# Hazardous Waste Ground-Water Task Force

## Evaluation of Land Reclamation, Ltd. Racine, Wisconsin

MAY 1988

**FIGURE 8**  
MONITORING WELL LOCATION MAP

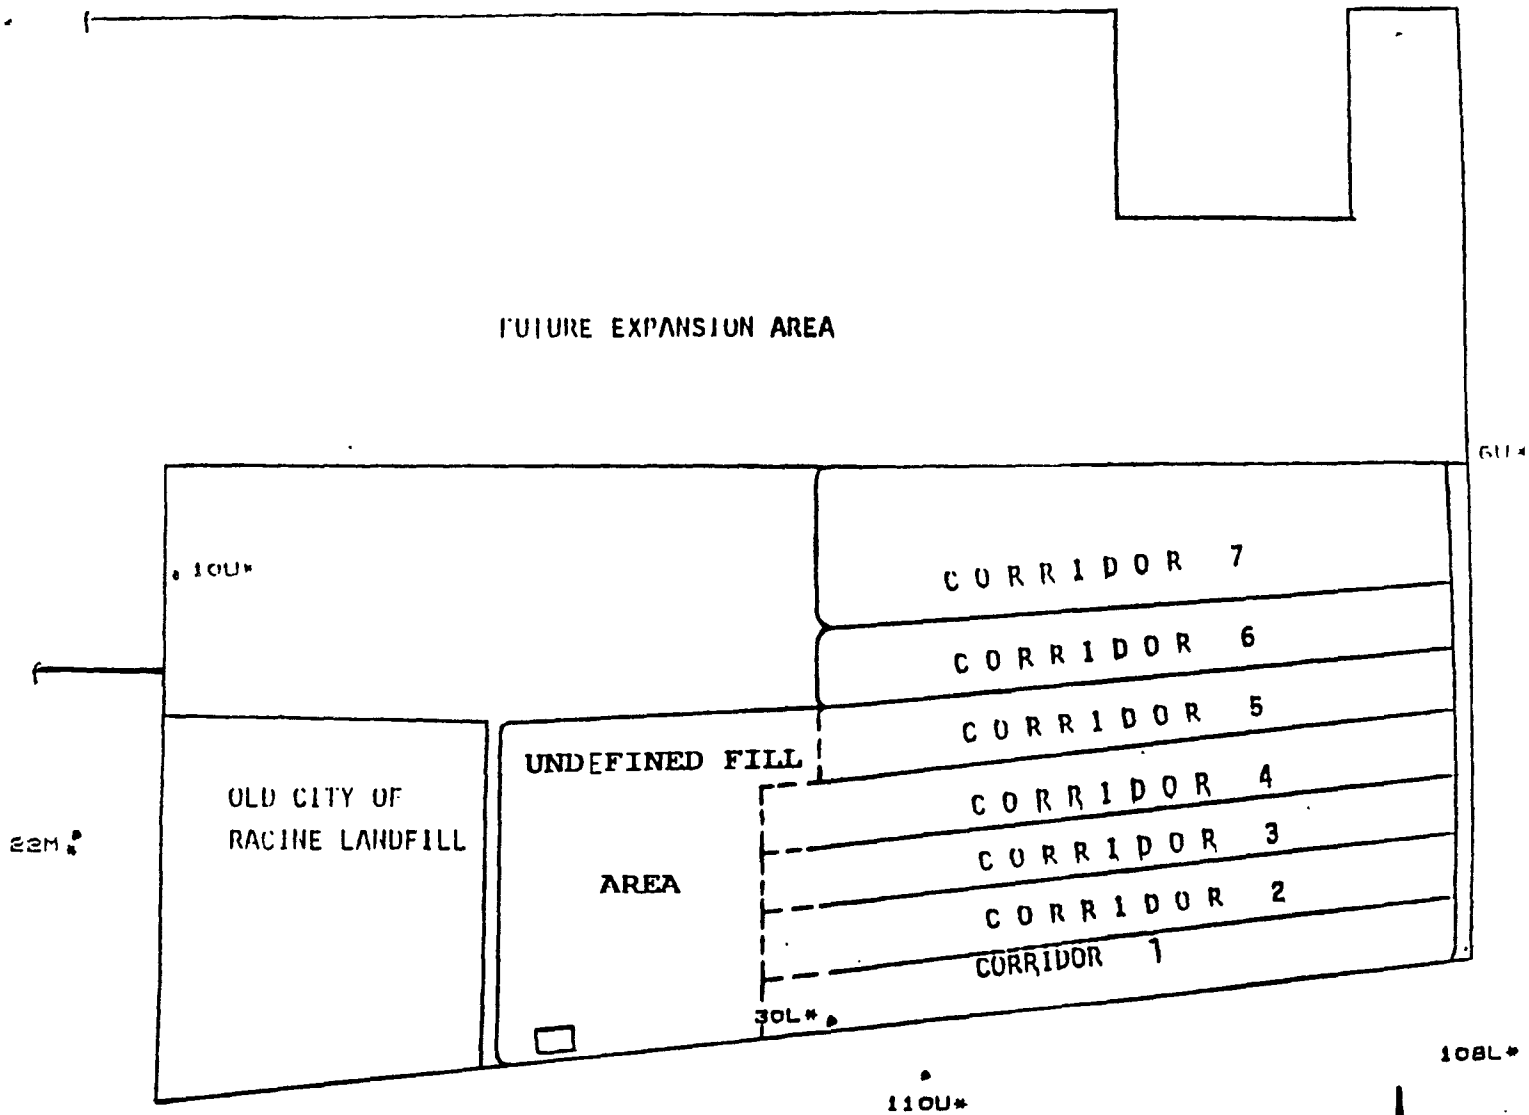
- 1) The six wells in the RCRA system are not sufficient. A greater number of monitoring points is required to provide for a more representative sampling of potential contaminant pathways.

- 5) In the present RCRA system, there are only three wells (30L, 108L, and 110U) along the south edge of Corridor 1. All present or future replacement wells along this side, from Well 19U to the series 18 wells, need to be included in the RCRA system. This is needed to detect any releases from the side of fill into the water table or the upper sand seam. Also, as can be seen in Figure 6, the piezometric surface of the lower sand seam, flow is directly south in this lower unit.

- 6) Only two wells (22M and 10U) along the west side of the site area are included in the RCRA monitoring system.
- 7) The two wells that LRL has designated as upgradient (6U and 108L) may be improperly classified. The facility's own data does not support LRL's claim that 6U and 108L are acceptable upgradient wells. Past sampling results for 6U have indicated contamination. Figure 6, the ground-water flow contour map in the lower sand seam, indicates that Well 108L may actually be downgradient. Well 6T also appears to be downgradient and is possibly contaminated as evidenced by WDNR data showing chloride concentrations ranging from 9 to 74 mg/l.
